Addendum No. 3
August 2, 2024

Project: Brandon Valley Elementary School
Brandon, South Dakota
Project #3023

Architect: Architecture Incorporated

FLOOR PLAN - ADD ALTERNATE #1
SCALE: 1/8" = 1'-0"

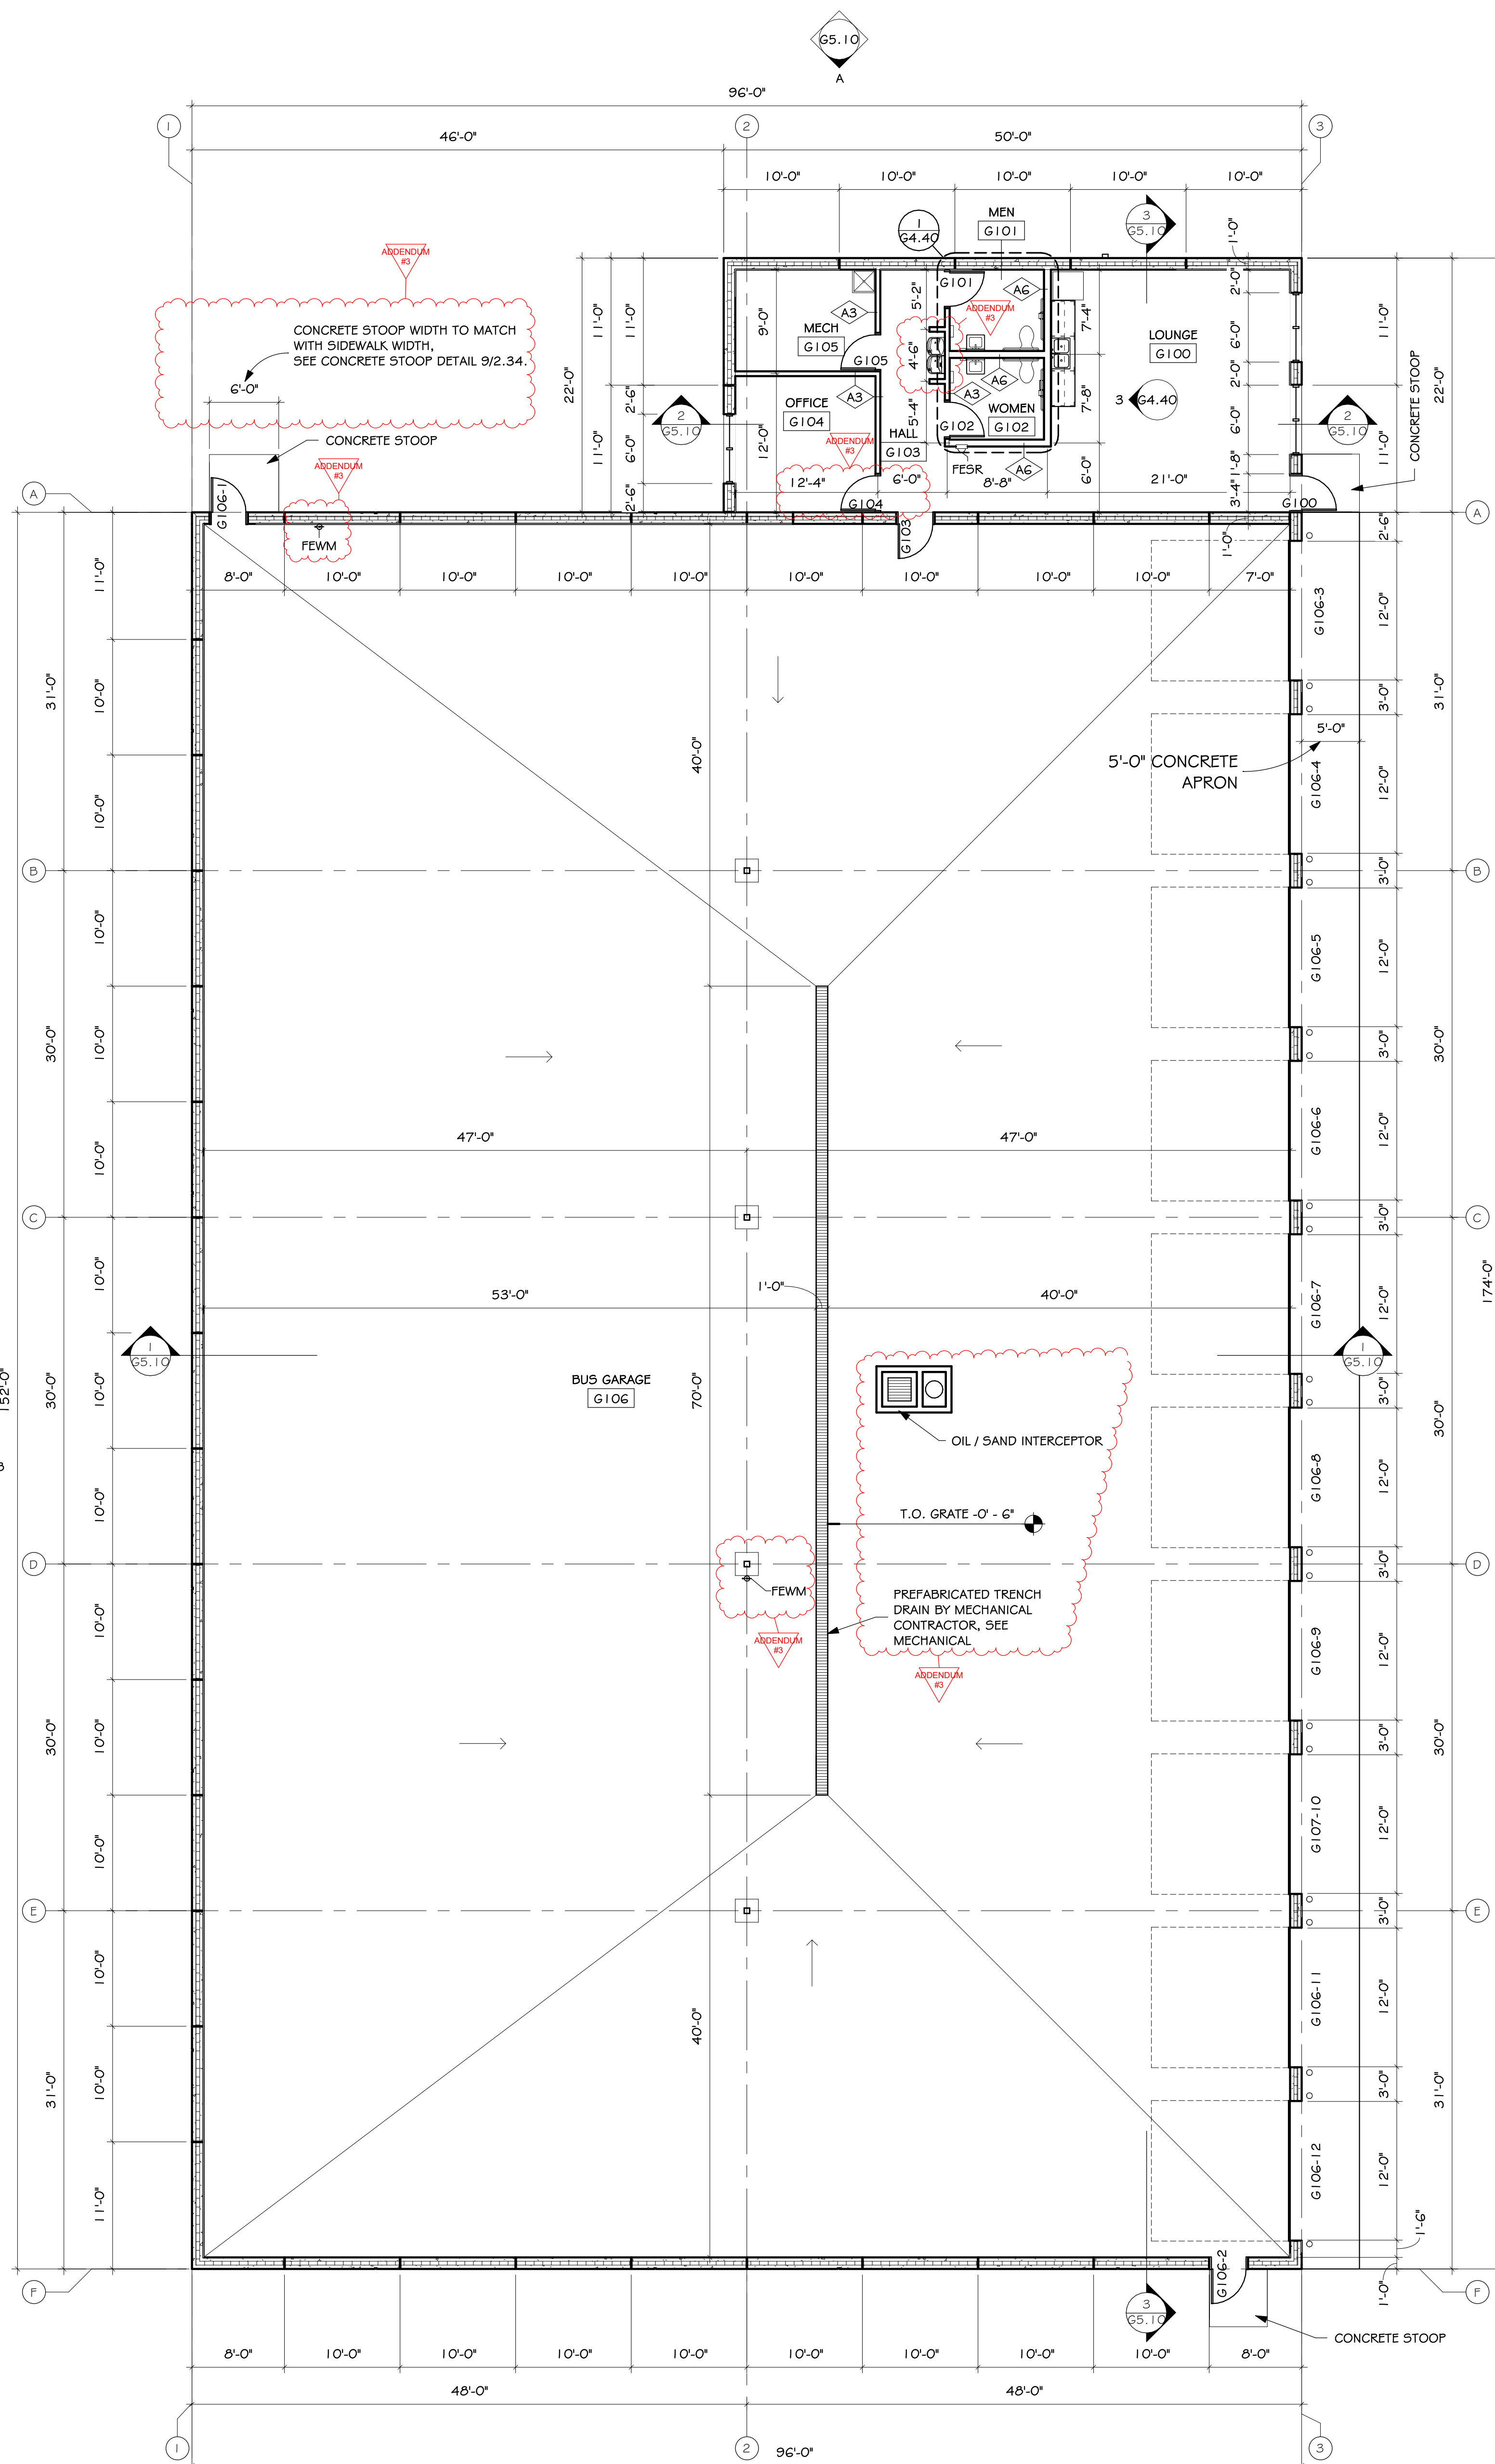
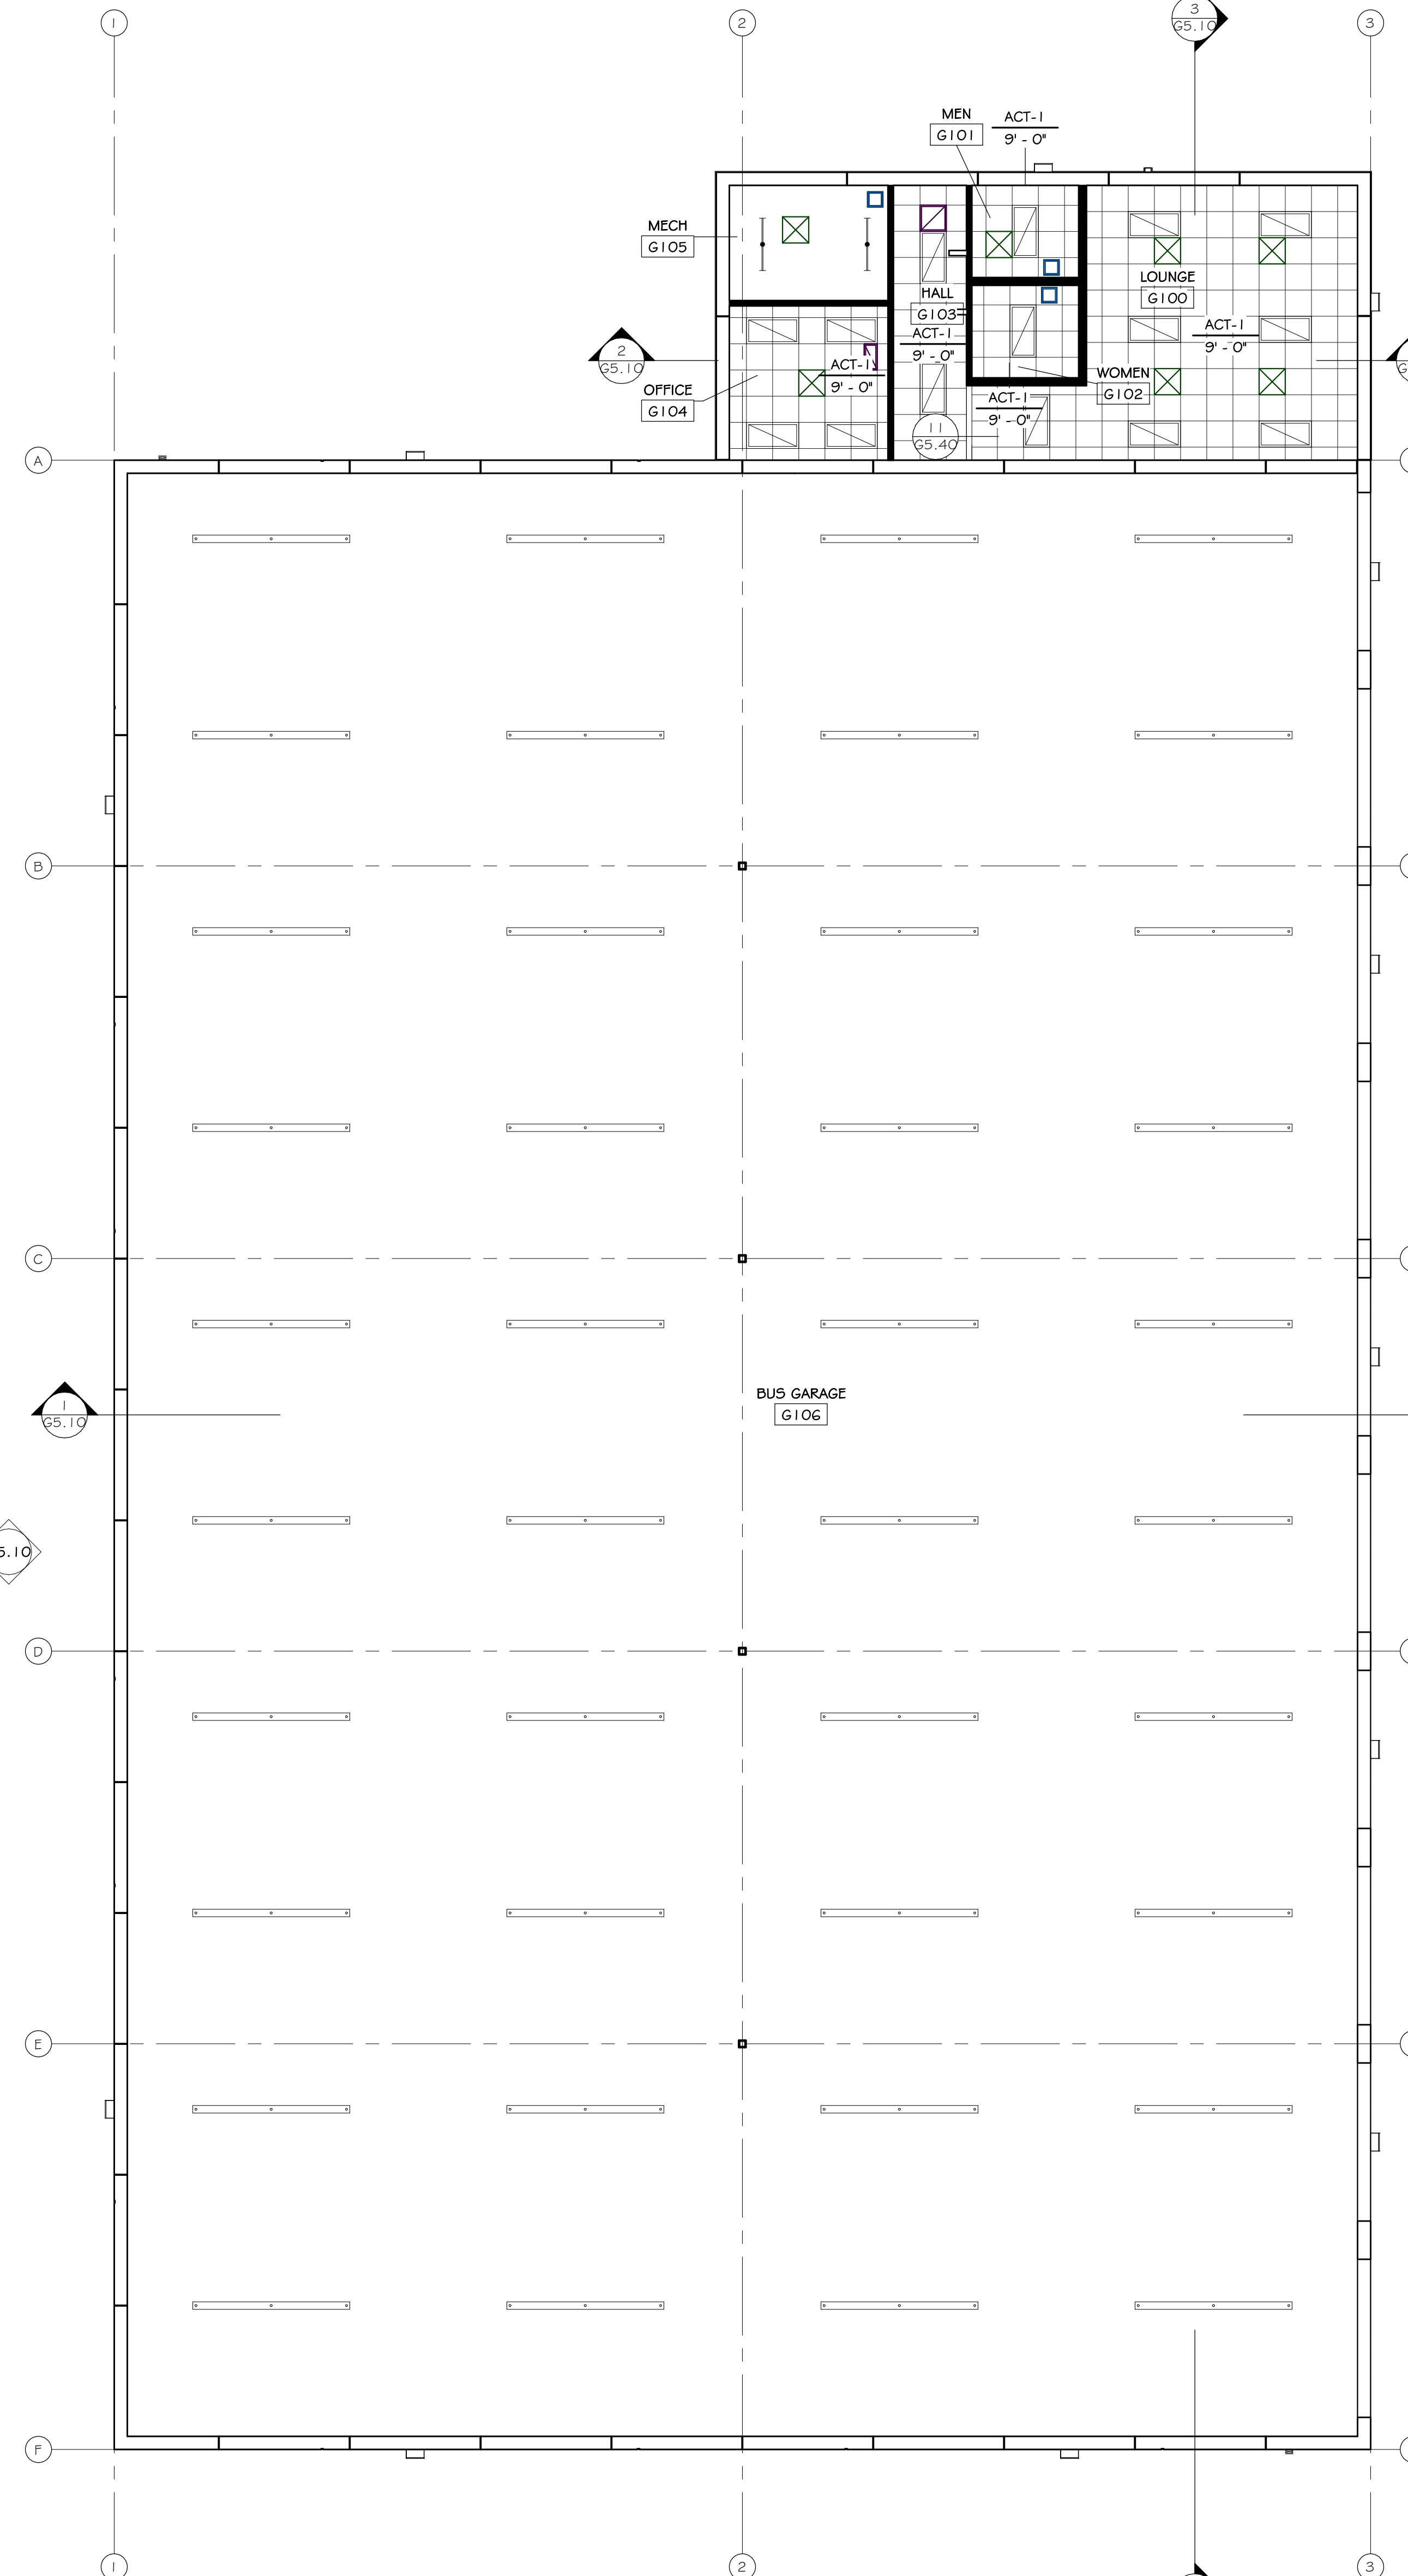
41) SHEET G4.10 – BUS GARAGE FLOOR & CEILING PLANS & FINISH SCHEDULE

- a) Reference revised Sheet G4.10, revision dated 8-2-2024 attached to the end of Addendum #3 for following modifications:
- i) Added notes at stoop as indicated – see concrete stoop detail on Sheet 9/2.34.
 - ii) Relocate semi - recessed fire extinguisher on the south wall of WOMEN G102 as indicated.
 - iii) Provide and install electric water cooler on the east wall of Hall G103 as indicated.
